AR-TEX COMPOSITE LTD. (EXTENSION)

18 November 2024

2. Observation

Ground floor beam layout plan

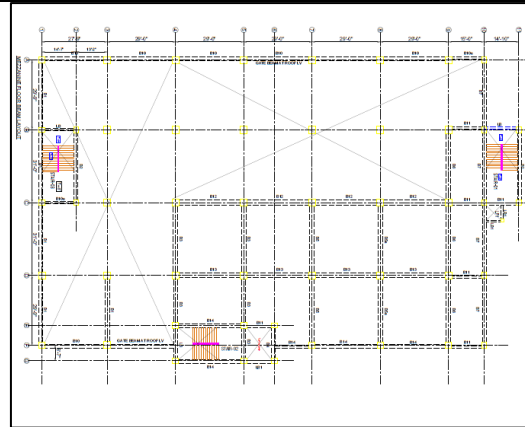
Observation 3: Lack of information in as-built structural drawing (Building-04).

Description: During inspection, tie beams with different levels were observed on the ground floor. However, structural information for tie beams with different levels was not incorporated in the structural drawing. The building engineer is required to survey the structure and update the as-built drawing as per BNBC.

6.	Lack of information in as-built structural drawing (Building-04).	The building engineer is required to survey the structure and update the as-built drawing.	within 6 weeks

Design Report

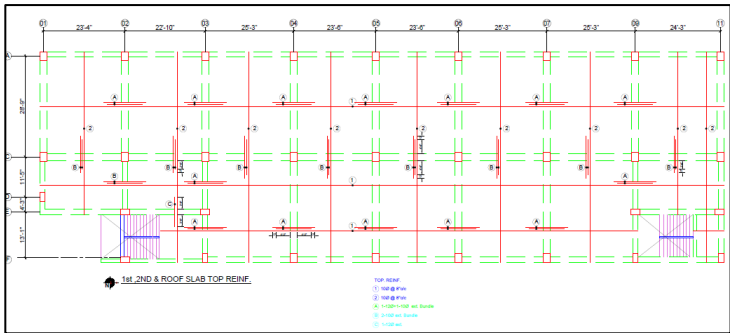
Observation 6: Inconsistency in the design report (Building-05).

Description: Seismic design consideration not comply with the BNBC. Building engineer need to address the inconsistencies and provide the necessary information in the design report. Produce the design report as per BNBC 1.9

9.	Inconsistency in the design report (Building-05)	Building engineer need to address the inconsistencies and provide the necessary information in the design report. Produce the design report as per BNBC 1.9.	within 6 weeks
